# LXT971A/972A PHY Transceivers

## Specification Update

*June 2001*

Order Number: [249354-005](#)

**Figure 1. Ordering Information - Sample**

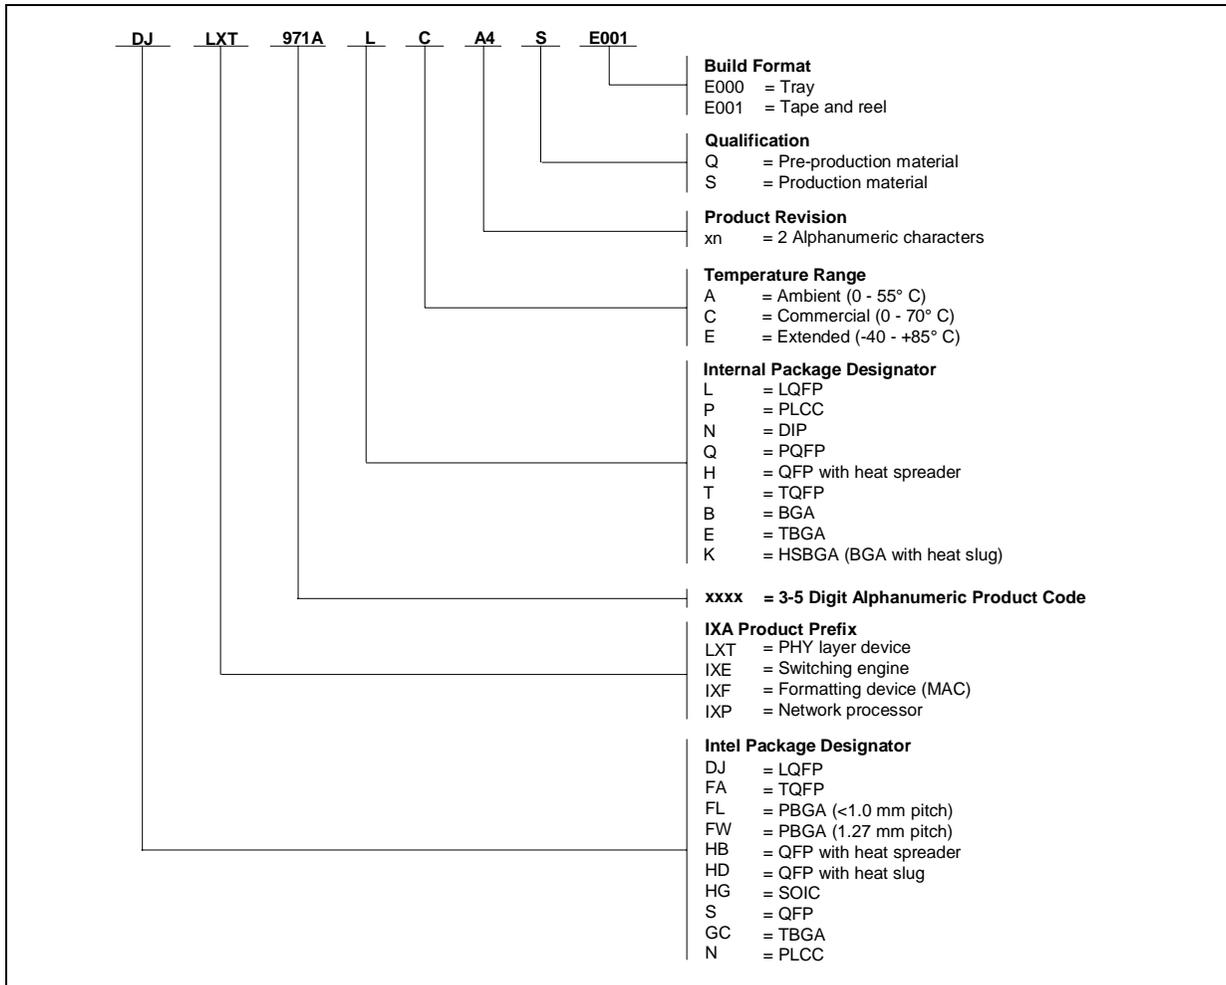
**Table 1. Product Information**
